DATE: January 17, 2024
TO: Franklin Planning Board
FROM: Department of Planning and Community Development
RE: 10 Kenwood Circle
Site Plan Modification

Re: Response to Traffic and Parking Management Plan Peer Review
OnTrac Warehouse Facility – 10 Kenwood Circle
Franklin, Massachusetts

**Re: 10 Kenwood Circle
Traffic and Parking Management Plan Peer Review**

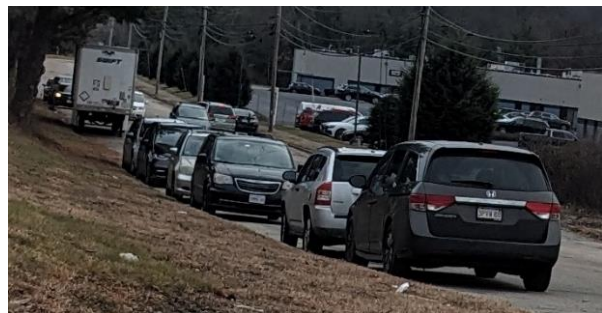
Observation: Two-way access appeared to be maintained during the observation period to the south of the vehicle queuing area. No cones were observed to show this space, as recommended by VAI in the Traffic and Parking Management Plan.

5. Consider striping the vehicle staging area to formalize the three queues and two-way access to the south.

Response: This queue area is expected to be utilized only during OnTrac's busy season (mid-to-late November through mid-to-late December), and then only for a period of two to three hours in the morning during OnTrac's busy season. Otherwise, this space can be utilized for additional parking at the site during all other times. Accordingly, OnTrac proposes signs to limit parking at this area only during restricted hours. OnTrac has not yet posted such signage because it is awaiting the town's determination and instruction in this regard. OnTrac will also use cones as recommended.

If instead it is the Planning Board's preference for OnTrac to stripe this area, OnTrac is open to it.
